Government of India  
Ministry of Railways  
Research, Designs &  
Standards Organization,  
LUCKNOW - 226011

File no. EL/1.2.9.1

**Sub:** Development of 2 x 130 KVA Static Converter (SIV), for Conventional Electric locomotive

**Scheme for replacement of 180 kVA SIV by 2 X 130 kVA SIV of new design.**

Fig 1

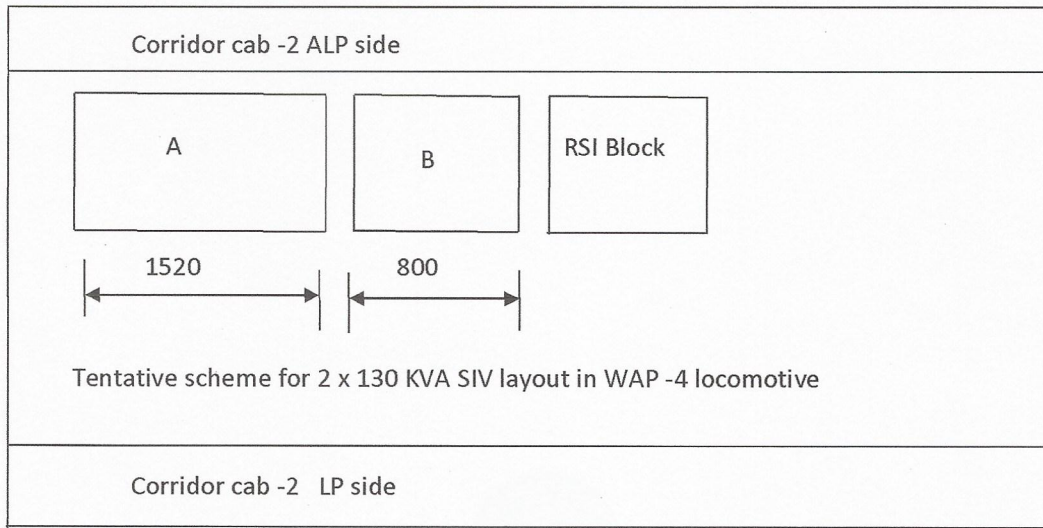
1. For WAP-4: "A" portion will be placed at the same place where 180 KVA SIV is located by slightly shifting towards cab side. ATFEX and RSI are to be shifted suitably so that Choke can be placed in between RSI and "A" unit of new design of SIV as mentioned in Fig 1 .

Fig.2

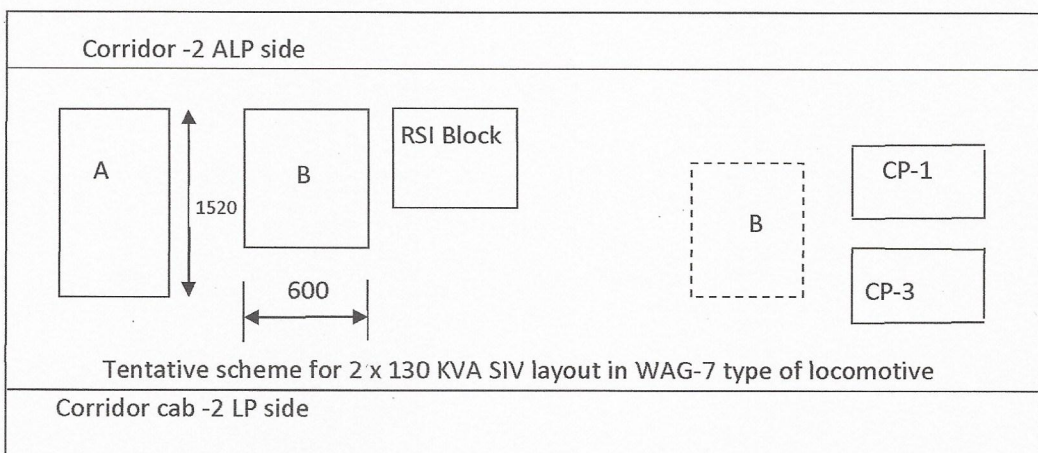
2. For WAG-7: "A" portion will be placed at the same place where 180 KVA SIV is located slightly shifting towards cab side. ATFEX and RSI are to be shifted so that Choke can be placed in between RSI and SIV unit as per the scheme shown in Fig 2. In the cases where space for choke is not available due to Vertical DBR, 2 x 1750 LPM compressors (oil lubricated or oil free) can be provided as per MS-0445 & MS 0451 in place of 3x 1000 LPM compressor and choke can be placed at CP-2 location as per the scheme shown below in Fig 2.
